Service Bulletin

PRELIMINARY INFORMATION

Subject: Steering Shudder (Vibration) During Slow Speed Maneuvers

Models: 2010-2013 Chevrolet Equinox
2010-2013 GMC Terrain
Equipped with Engine RPO LF1, LFW or LFX

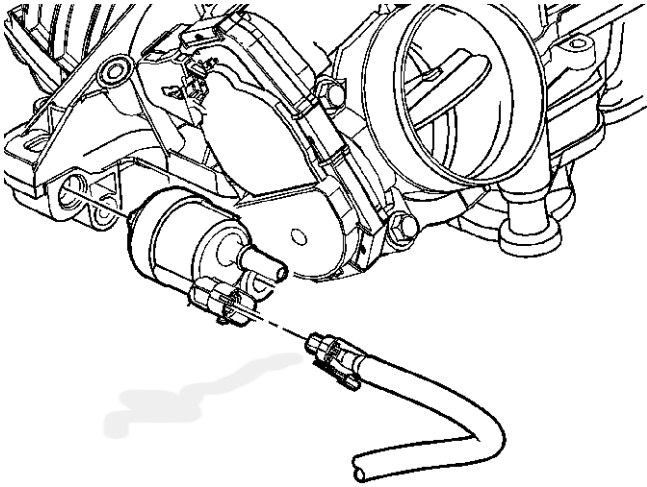
This condition can be corrected by replacing the following components: power steering gear inlet hose assembly, generator (alternator) assembly and the emission evaporative hose. The revised power steering hose assembly is longer and provides a dampening quality. The revised generator has an isolation pulley and the revised evaporative hose is designed to clear the revised power steering hose.

Important: When the revised components (hoses) are installed, they must not have contact with the underbody or components. Use care to position the hoses to prevent any contact with other components.

1. Install the revised generator. Refer to Generator Replacement in SI.
2. Install the revised power steering inlet hose. Refer to Power Steering Gear Inlet Pipe/Hose Replacement in SI. Leave the intake manifold cover off.
3. Install the revised evaporative emission canister purge hose assembly as follows:

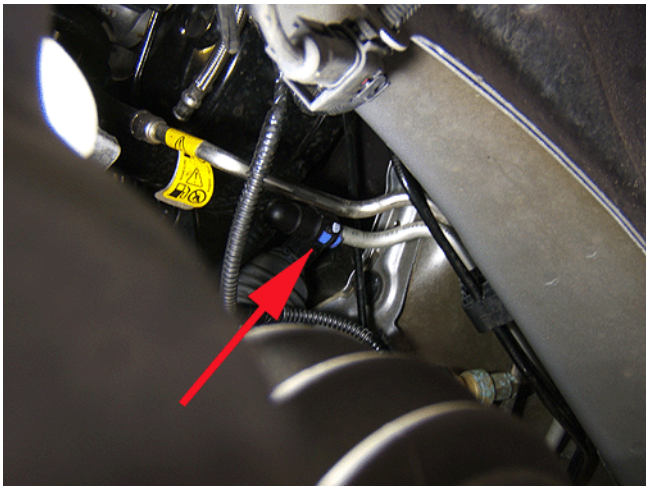
3.1. Disconnect the hose from the evaporative emission canister purge solenoid valve located by the base of the throttle body.

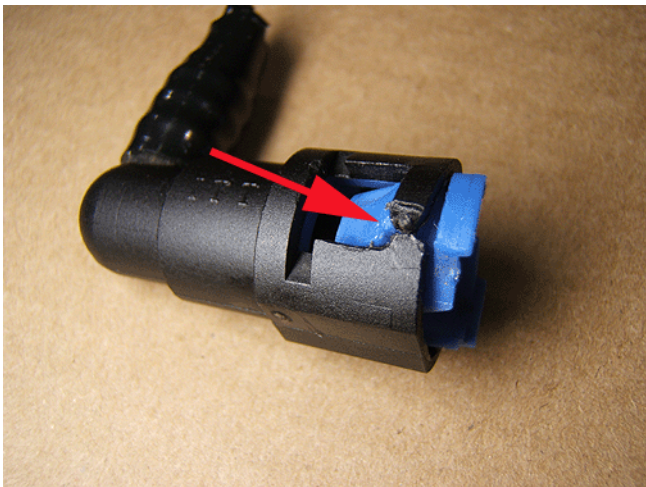
3.2. Disconnect the hose from the chassis to canister evaporative emission line.

It may be necessary to cut the plastic connector on the hose if the blue plastic retention collar cannot be released. A new connector is part of the new hose assembly.

3.3. Remove the existing hose and install the new hose assembly.

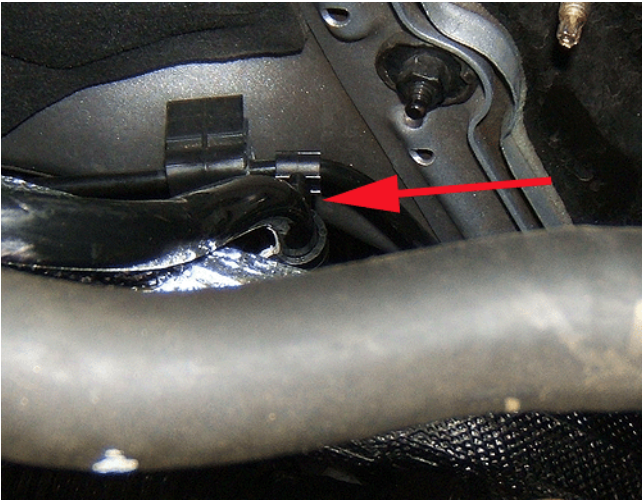
Route the new hose in a way that avoids contact with chassis and body components. Connect both ends of the hose.

4. Install the clip as shown, connecting the new evaporative emission canister purge hose assembly to the black metal cross car brake pipe.
5. Inspect the new evaporative emission canister purge hose assembly and the revised power steering inlet hose to ensure no components are coming into contact with the new hose assemblies. If contact is present, loosen and reposition the new hose.
6. Fill and bleed the power steering system. Verify the fluid level. Repeat the bleed procedure, if necessary. Refer to Power Steering System Bleeding in S
7. Reinstall the intake manifold cover.
